Re: Tarrawonga Coal Mine Expansion Project Project Application Number: MP11_0047-Mod-7

Tarrawonga Coal Mine Mod 7

Project Application Number: MP11_0047-Mod-7

Maules Creek Community Council Inc

Low Permeability Barrier

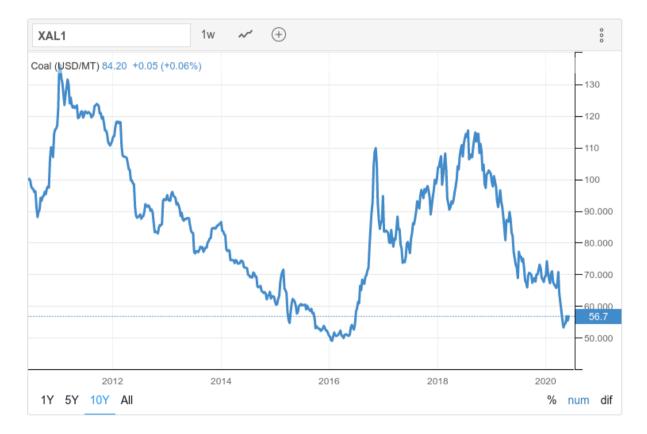
It seems inevitable that once Tarrawonga obtained its 2013 expansion approval it would seek an opportunity to renig on its requirement to implement the Low Permeability Barrier. At the time the MCCC expressed reservations in its submission:

"It is the view of the MCCC that the proposed "bund" and creek "re-alignment" is a doubtful and complex long term engineering solution to a simple problem. "⁵

At the time, we said that the creek should be left to it's natural course and that the mine should be kept away from groundwater including the "perched" groundwater table near Goonbri Creek.

The costs of environmental protection should be internalised by the proponent, not externalised to the environment and the community. The Low Permeability Barrier should be retained as per the original approval conditions.
